ON-SITE SEWAGE DISPOSAL SYSTEM HOWARD COUNTY HEALTH DEPARTMENT BUREAU OF ENVIRONMENTAL HEALTH

IMPROVEMENT LOCATION SURVEY
 LOT 7 Block 'A'
 PLOT ONE
 MOORESFIELD
 FIFTH ELECTION DISTRICT
 HOWARD COUNTY, MD

RE: 7530 Cherry Tree Drive
Map 41, Grid 20, Parcel 279, Lot 7
Setback Variance Request

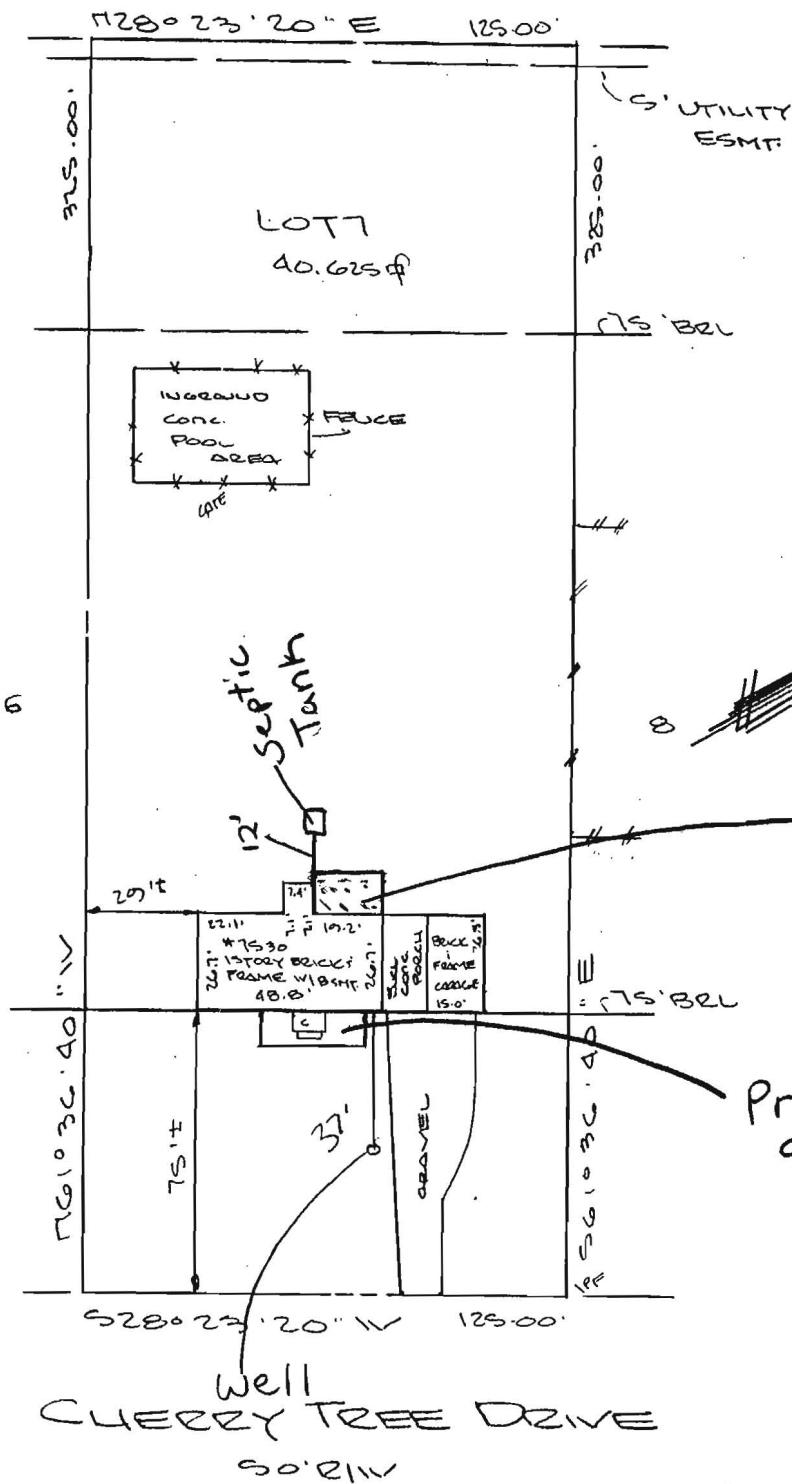
10/17/2006
 Told Applicant to Apply For Septic Repair Permit - May Have to Do More Perc. Testing, System Must Be Repaired Before Any Building Permits are Signed.

Proposed 9x27' front porch

We have received your variance requesting the required 10' setback of the septic tank to a deck/patio be waived to 5'. This agency will grant you **approval** for the variance as long as no part of the deck overhang is within 5' of the septic tank and post and pier footers are utilized.
